PCN No.: PCN # 069

Product Change Notice: XPort AR Evolution Firmware Version 3.0.0.1R8

Revision Tracking Information on XPort Label

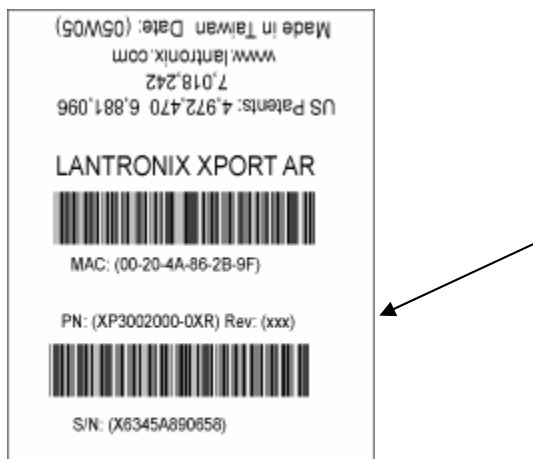
For quality and tracking purposes, the manufacturing revision numbers on the product label will be changed as indicated further below.

Please note that the revision information for the XPort product is as shown below:

XPort Part Numbers	Description	Current Revision	New Revision
XP3002000-01R	Standard XPort AR Bulk Pack RoHS	A12	B12 or higher
XP300200S-01R	Standard XPort AR Sample RoHS	A12	B12 or higher
XP300200K-01	Standard XPort AR Evaluation Kit	A16	A16 or higher
